City of Richmond

Report to Committee

To: Public Works and Transportation Committee *to Public Works & Transportation - Jun 21, 2006* **Date:** June 5, 2006
From: Robert Gonzalez, P.Eng. **File:** 10-60450-01
 Director, Engineering **Xref:** 10-6045-08-01
Re: **East Richmond Agricultural Water Supply Study**

City of Richmond
 East Richmond Agricultural Water Supply Study
 East Richmond
 PHASING PLAN

MAP 6.1

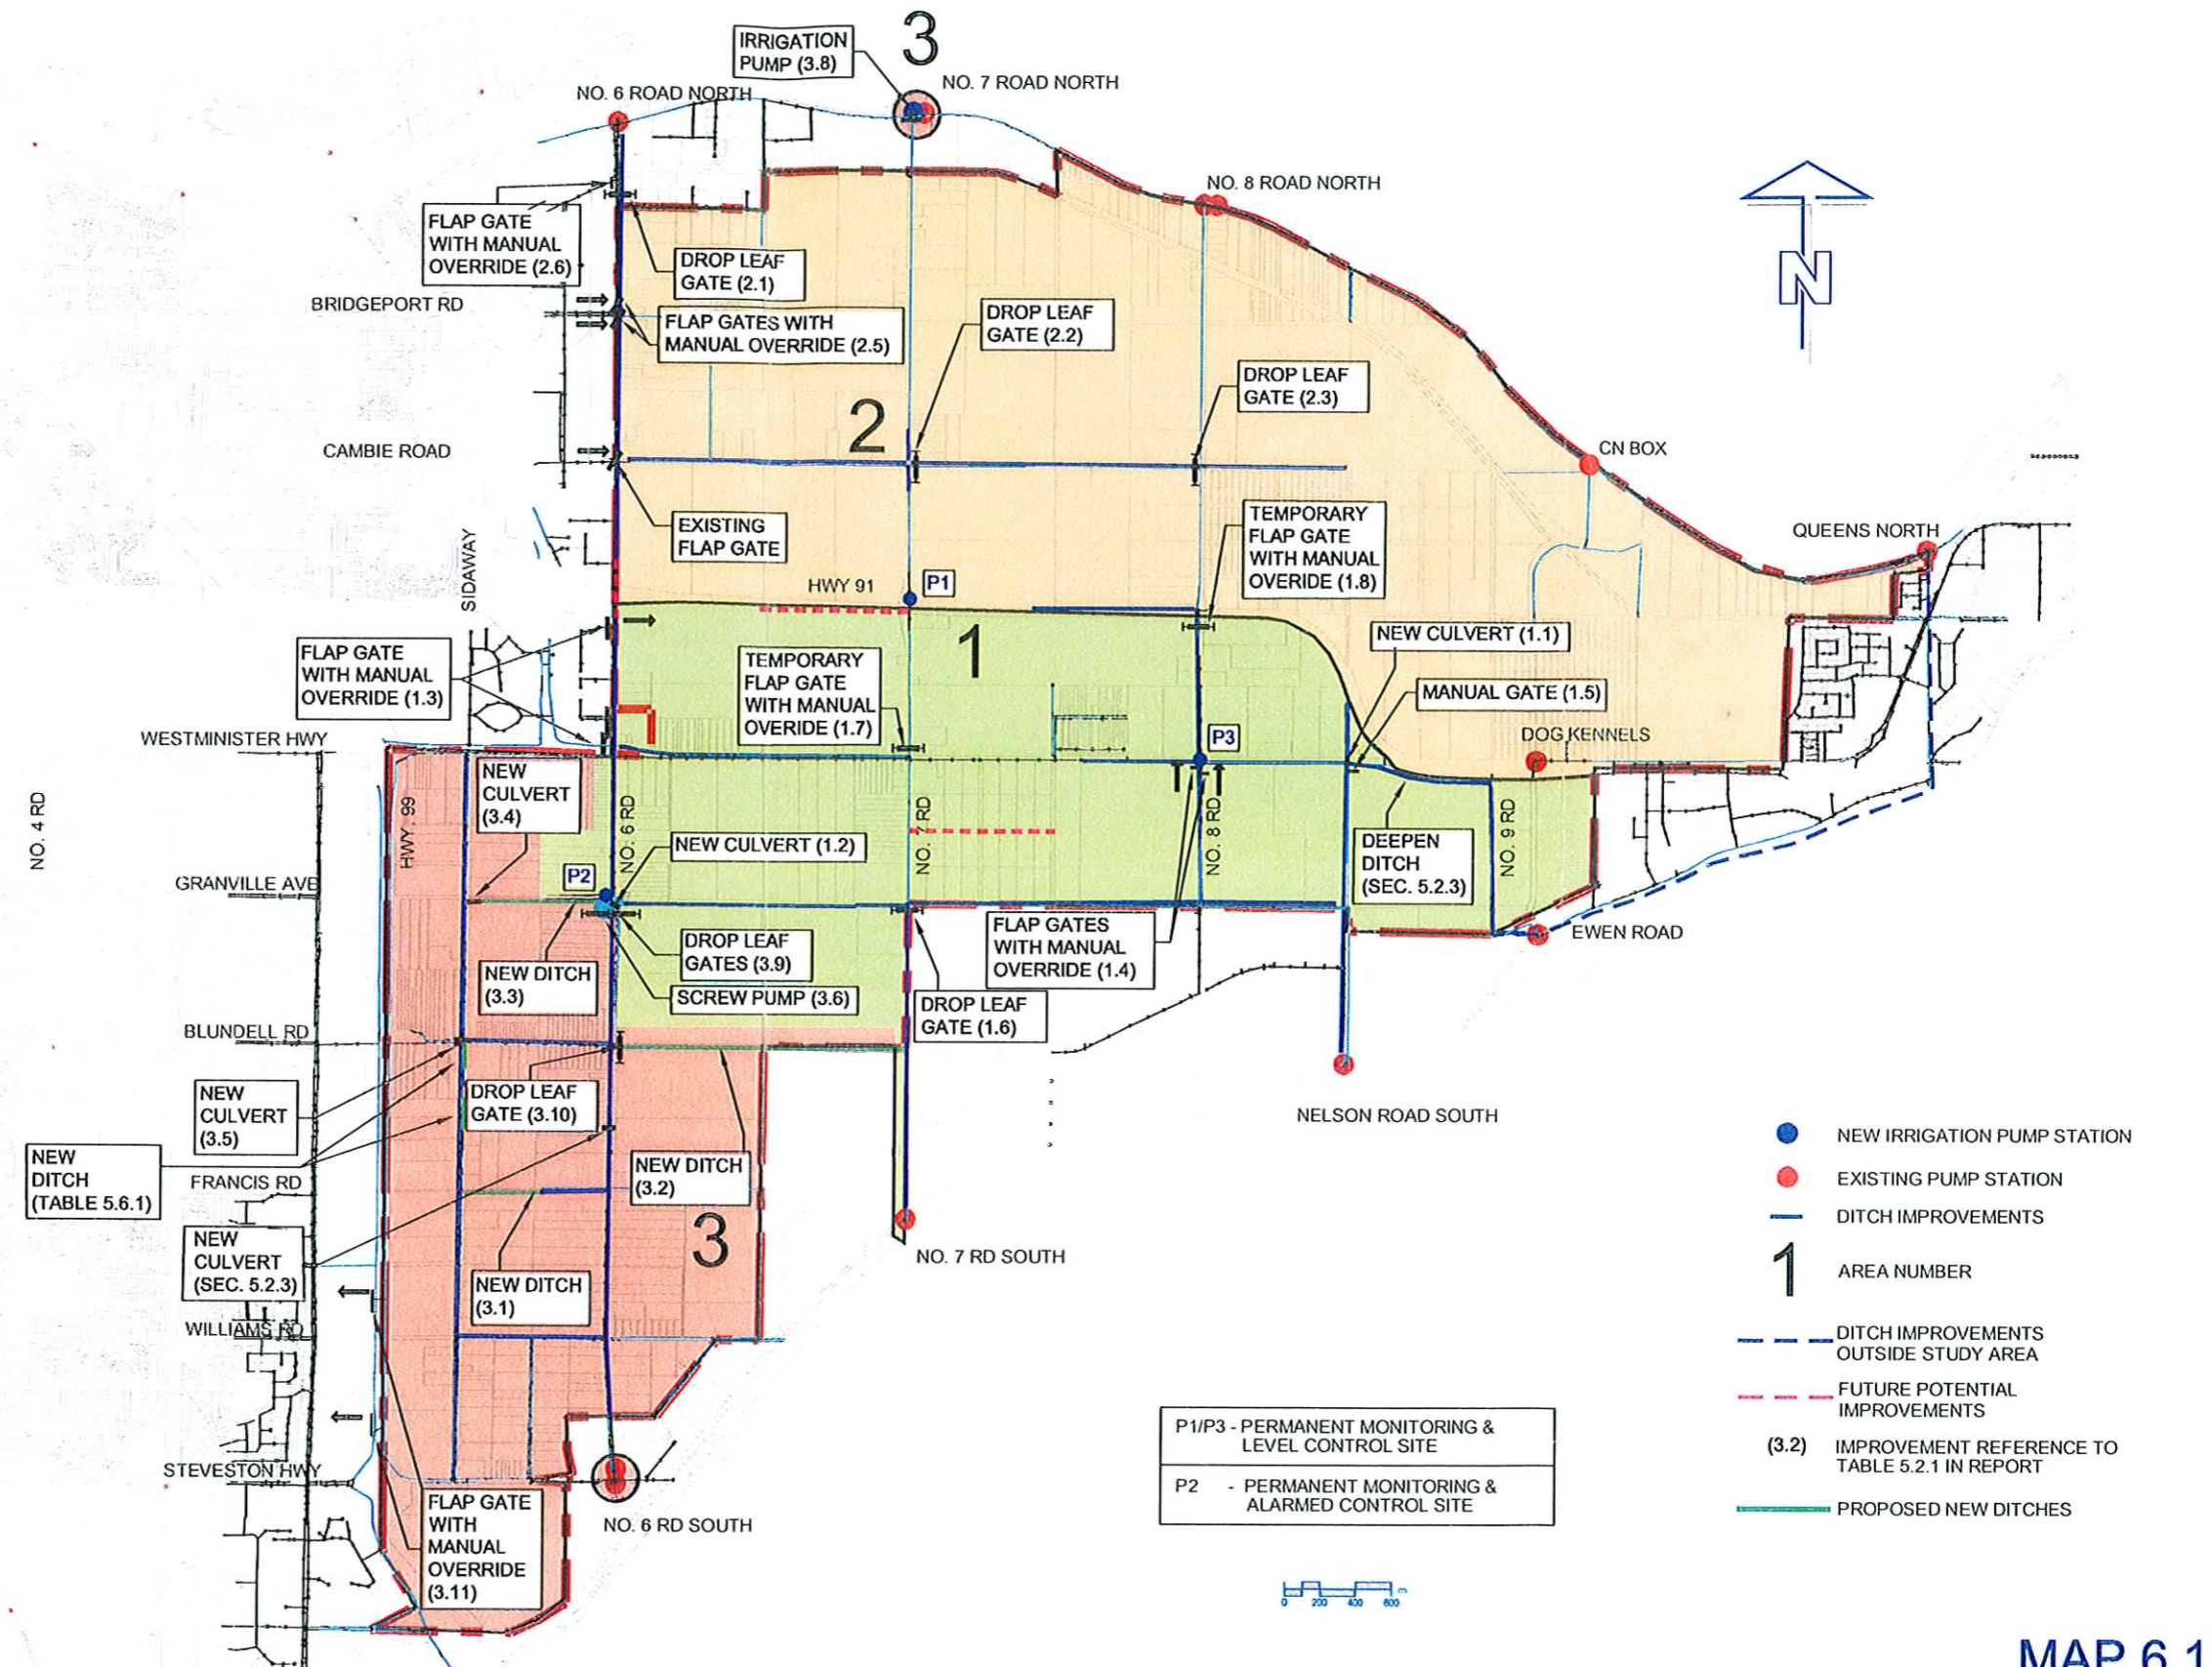
1. Water that is allowed to come from river on North
Branch of Fraser for use by cranberry growers and the
use and release after use:

2. Use by houses in Area 3 of map

3. Flooding of farm land and crop damage in
Area 1 of Map.

2004 and 2005 water flooded and damaged
crops near property, when allowed into the
ditches and from the river, also damage
after release from cranberry use for harvesting

1. Containment of water in area 2 before
and after use, not allowed to flow into
Area 1 and 3.

2. Use of #7 Road ditch to flow water to Area 1
water will flow down (East of #7) to Westbound
Highway ditch. to flood land in our area
as no control is shown to stop this flow.

3. Ditch clearing should be improved and new
ditches dug.

- 1 new pump. at # 7 Rd and like.
- 2 some control on flap gate at # 7 Rd and Brevelle to allow water out of east of # 7 Rd.
3. Legal (Who is legally responsible??)
From Lim Belmie for
HC Belmie + Sons Farms
6220 # 8 Rd.
